PROJECT: **COCKAYNES LANE, ALRESFORD, ESSEX.**

DRAWING TITLE: **LANDSCAPE PROPOSALS (SHEET 1 of 6)**

SCALE	DATE	DRAWN	CHECKED	DRAWING NUMBER
1:250@A1	01.09.22	CB	AH	22.5293.10
No dimensions are to be scaled from this drawing. All written dimensions to be checked by the contractor. Discrepancies notified immediately to this consultant.

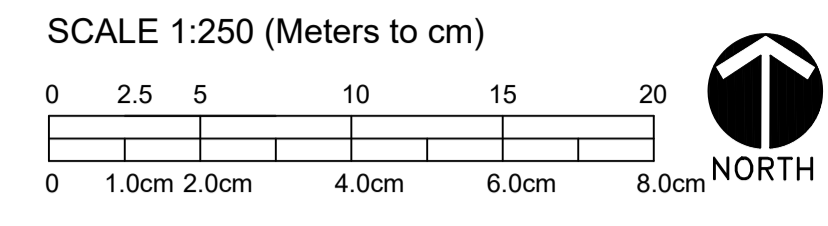
REVISIONS
A: 4m HIGHWAY VERGE TREES ADDED BACK INTO EDGE OF ORCHARD AS INSTRUCTED. 3NO ORCHARD TREES ADJUSTED TO ACCOMMODATE THESE TREES
12.07.23
